# Der Brochen Dam

## FOURTH DAM SAFETY EVALUATION REPORT

DAM SAFETY INSPECTION CARRIED OUT ON 27 JULY 2010 AS  
REQUIRED IN TERMS OF GOVERNMENT NOTICE R. 1560 OF JULY 1986

**Photo 1: Upstream section of side channel spillway (2010/07/27)**

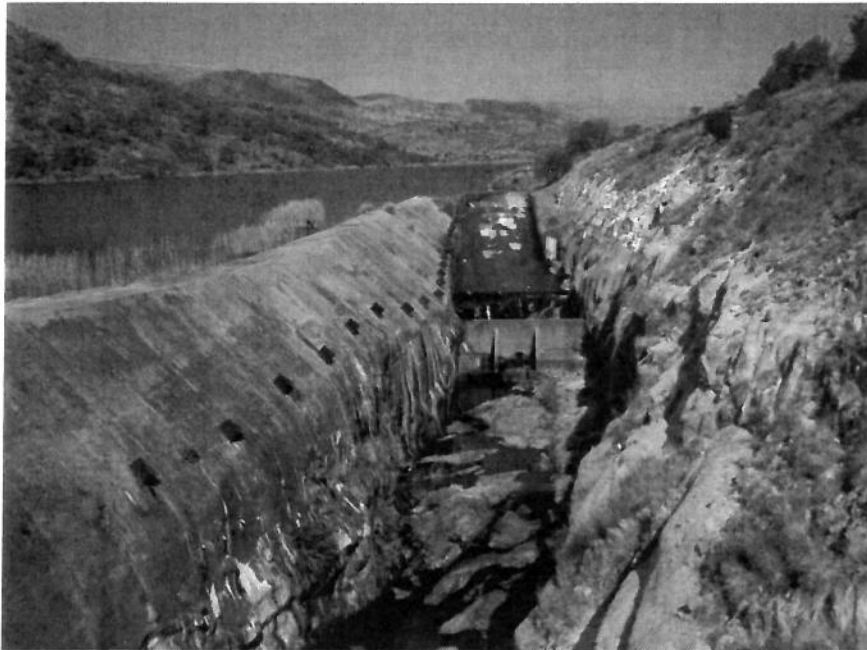
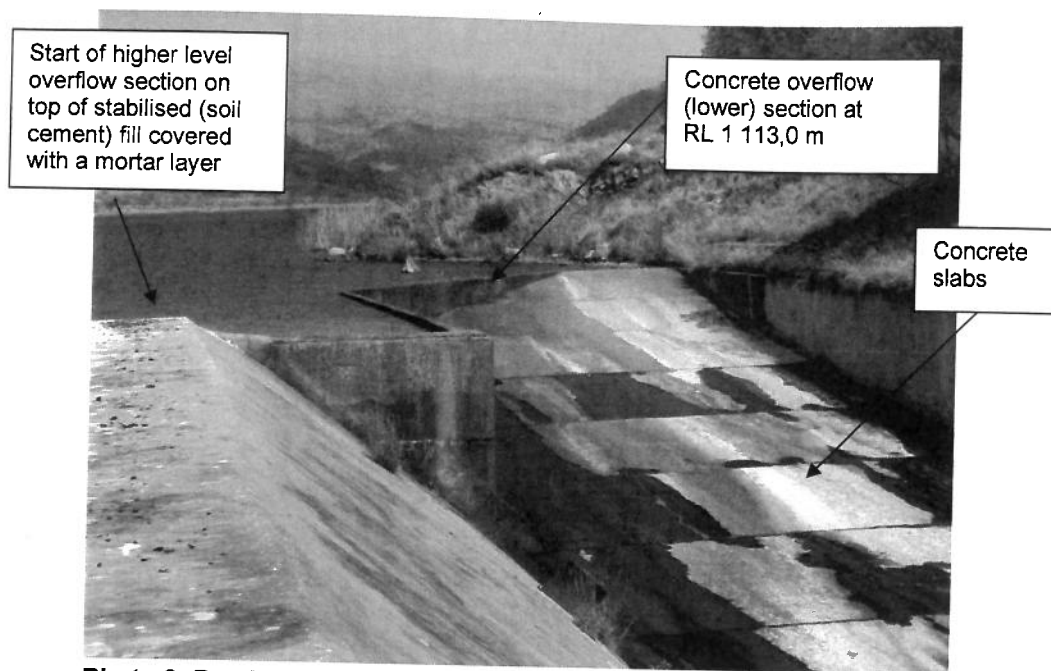
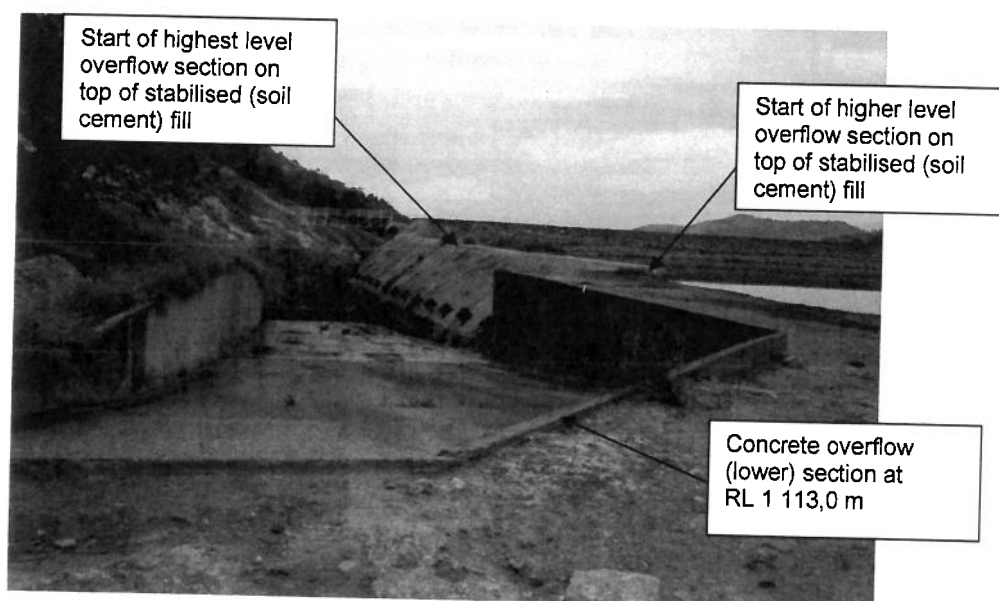
It was noted during the second and third dam safety inspection reports (2001 and 2005) that the original spillway capacity as calculated during the design phase was not entirely correct as only one of the two cross walls were actually constructed. The discharge capacity was recalculated in 2001 and resulted in a capacity marginally higher than in the original design. The maximum discharge capacity at RL 1 116,5 m is stated to be 799 m<sup>3</sup>/s. Routing of the flow was also done and it was stated that the maximum incoming flood with zero freeboard is 972 m<sup>3</sup>/s (resulting in a capacity of 799 m<sup>3</sup>/s). Table 5.1 shows the figures that were calculated from the 2001 report (Kramer).

A survey of the dam was done during 2010 by Directorate: Spatial and Land Information Management (D: SLIM). The survey shows deviations from the original design slopes and levels. The minimum NOC level of the embankment is RL 1 116,06 m, whilst the design value is RL 1 116,50 m.

Figure 5.1: Spillway discharge curve

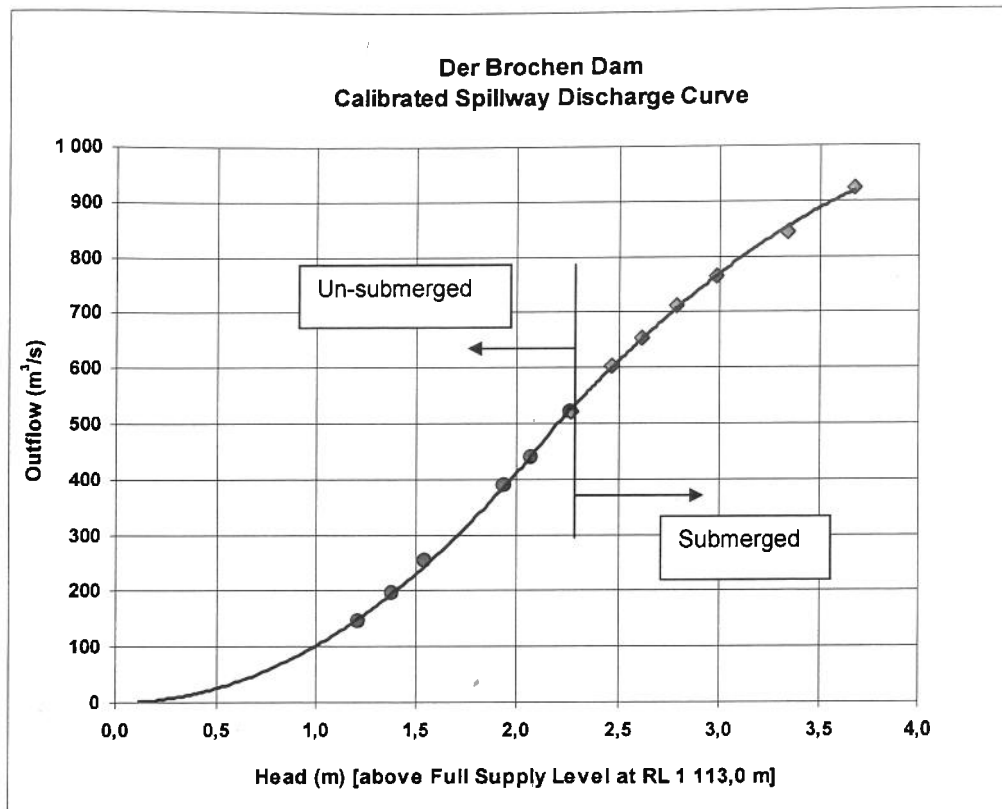
**Figure 5.1** shows the maximum spillway capacity. The maximum capacity at the design NOC at RL 1 116,5 m was calculated at 886 m<sup>3</sup>/s. The discharge capacity at the surveyed (2010) crest level of RL 1 116,0 m is 764 m<sup>3</sup>/s.

Figure 5.2: Routed flows (Van Deventer 2010)

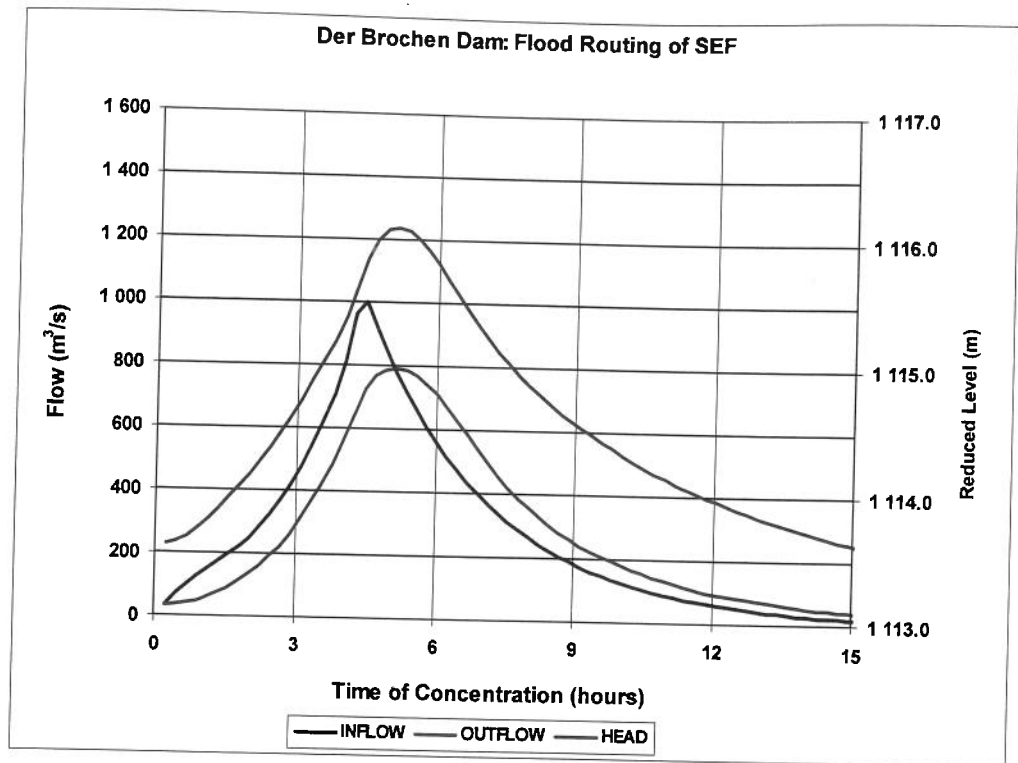
Routing of the inflowing peak of 1 000 m<sup>3</sup>/s was done. The out flowing peak was determined as 793 m<sup>3</sup>/s. This is less than the spillway capacity if the NOC would be at RL 1 116,50 m. Figure 5.2 shows the flood routing.

The spillway cannot accommodate the routed SEF. It can however accommodate a routed flood peak with a probability of exceedance  $6,66 \times 10^{-4}$ .

**Photo 10: Manhole 7 on the left bank with seepage water ponding on the inside due to a blocked outlet pipe (2010/11/17)**

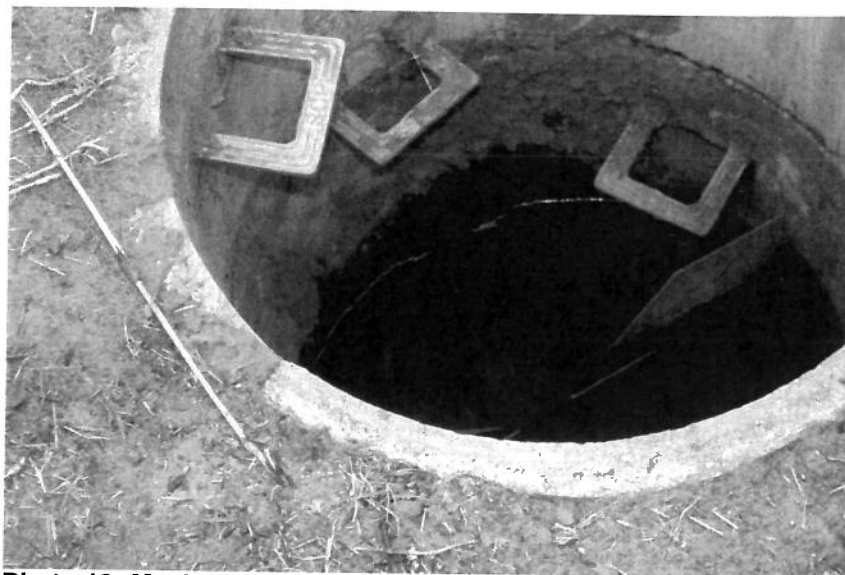
- Manhole 6: Manhole is silted up. Reeds are present. Stormwater ponds around the manhole.
- Manhole 7: Standing water is present in manhole with slight in-flow. The outlet drainage pipe is blocked.

**Photo 26: Side channel spillway and retaining wall at the connection between the spillway and earthfill embankment. It is recommended that a safety barrier be provided to prevent personnel from falling into the spillway.**

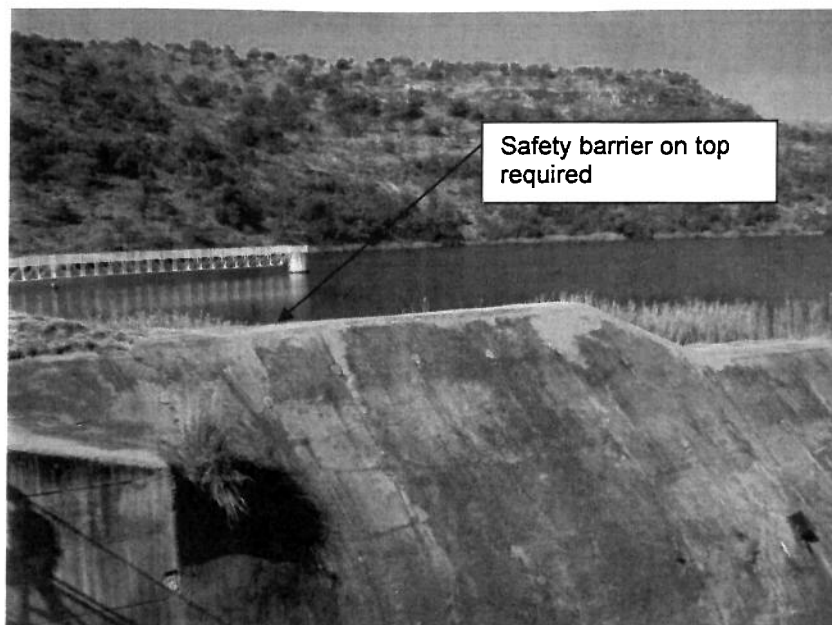
Grass growing in the cracks of the spillway crest is to be removed. The loose spillway cladding will wash away during a flood event. The mortar cap sounds hollow below when tapped. It is recommended that cladding be redone. It is recommended that a safety barrier be provided to prevent personnel or members of the public who gain unrestricted access, from falling into the spillway.
